UNITED STATES
DEPARTMENT OF THE INTERIOR
BUREAU OF LAND MANAGEMENTFORM APPROVED
OMB NO. 1004-0137
Expires: January 31, 2018**SUNDRY NOTICES AND REPORTS ON WELLS**
*Do not use this form for proposals to drill or to re-enter an abandoned well. Use form 3160-3 (APD) for such proposals.*5. Lease Serial No.
NNMN121473

CHEVRON U.S.A. INC <4323>

30-015-43936

PURPLE SAGE, WOLFCAMP (GAS)

BLOWOUT PREVENTOR SCHEMATIC

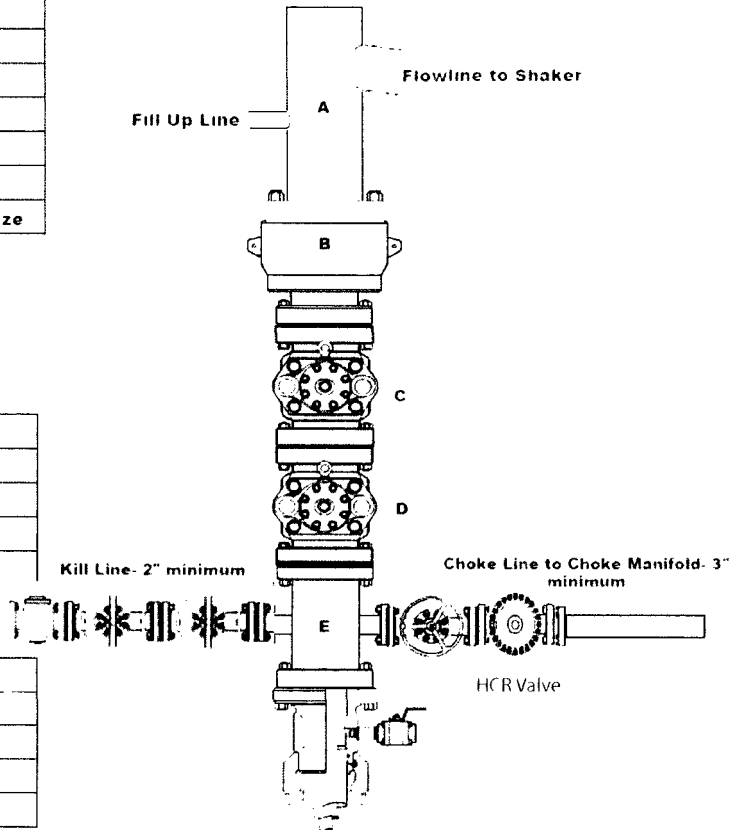
1) Change from 10M BOPE to 5M BOPE (all equipment will be 10M as per the original submittal, but the annular will be 5M)

Chevron respectfully request the ability to change the BOPE rating for the selected wells mentioned at the header, from a 10M system to a 5M system. The maximum mud weight at 10500' for the pore pressure is a 13.0 ppg. The MASP under these assumptions will be 4788 psi. The attached documents below reflect a 5M system BOPE rating and test procedures.

5M system requires an HCR valve, remote kill line and annular to match. The remote kill line is to be installed prior to testing the system and tested to stack pressure.

Diagram B

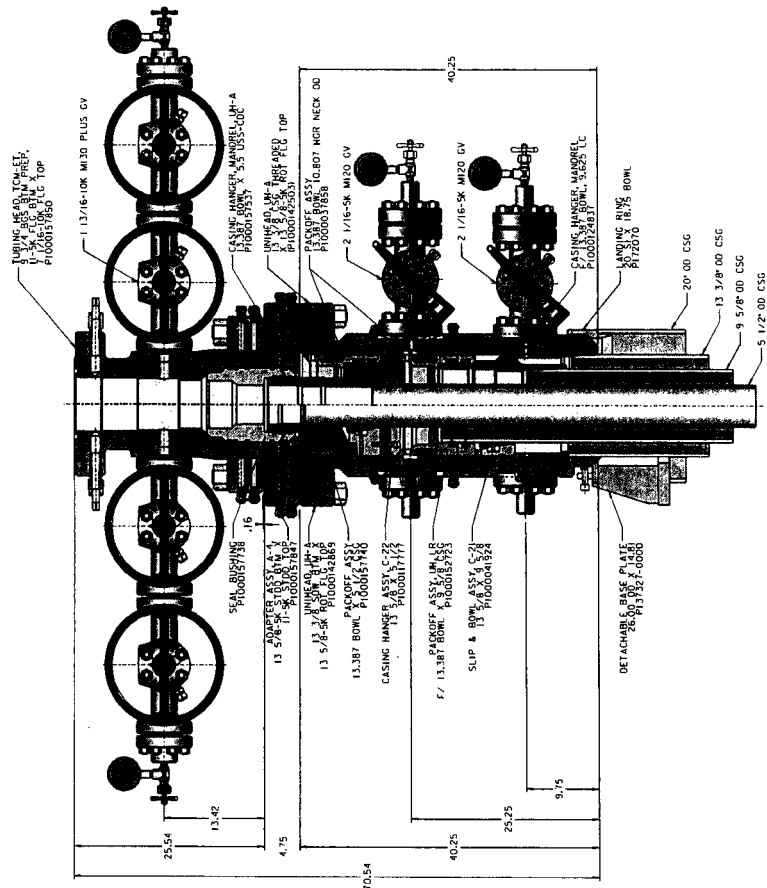
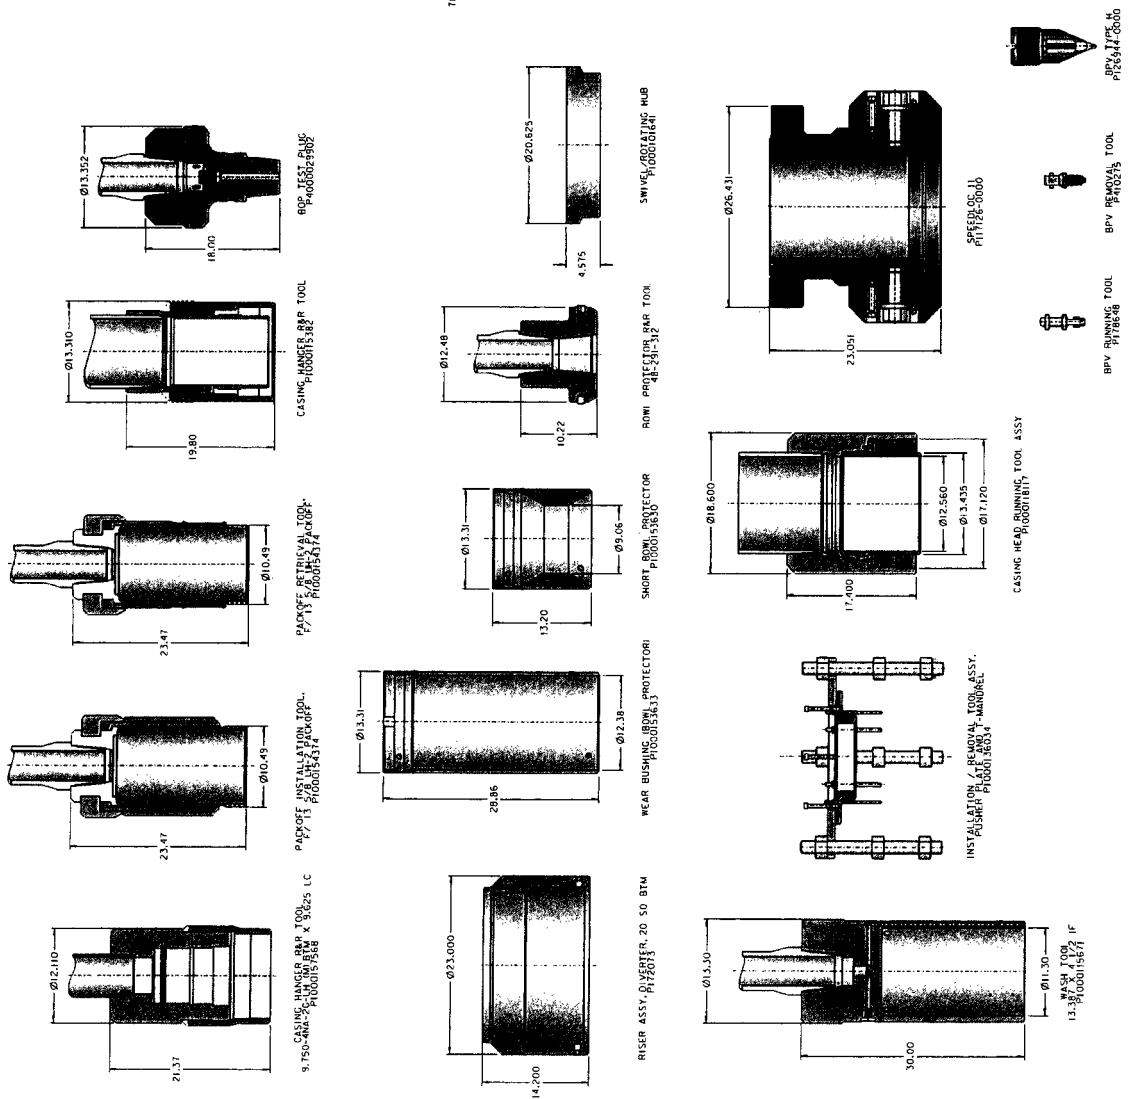
2) Utilizing a FMC UH-2 MultiBowl wellhead for development wells.

Chevron requests a variance to use a FMC Technologies UH-2 MultiBowl wellhead, which will be run through the rig floor on surface casing. BOPE will be nipped up and tested after cementing surface

casing. Subsequent tests will be performed as needed, not to exceed 30 days. The field report from FMC Technologies and BOP test information will be provided in a subsequent report at the end of the well. Please see the attached wellhead schematic.

Operator has proposed a multi-bowl wellhead assembly. This assembly will only be tested when installed on the surface casing. Minimum working pressure of the blowout preventer (BOP) and related equipment (BOPE) required for drilling below the surface casing shoe shall be 5000 (5M) psi.

- a. Wellhead shall be installed by manufacturer's representatives, submit documentation with subsequent sundry.**
- b. If the welding is performed by a third party, the manufacturer's representative shall monitor the temperature to verify that it does not exceed the maximum temperature of the seal.**
- c. Manufacturer representative shall install the test plug for the initial BOP test.**
- d. Operator shall perform the intermediate casing integrity test to 70% of the casing burst. This will test the multi-bowl seals.**
- e. If the cement does not circulate and one inch operations would have been possible with a standard wellhead, the well head shall be cut off, cementing operations performed and another wellhead installed.**
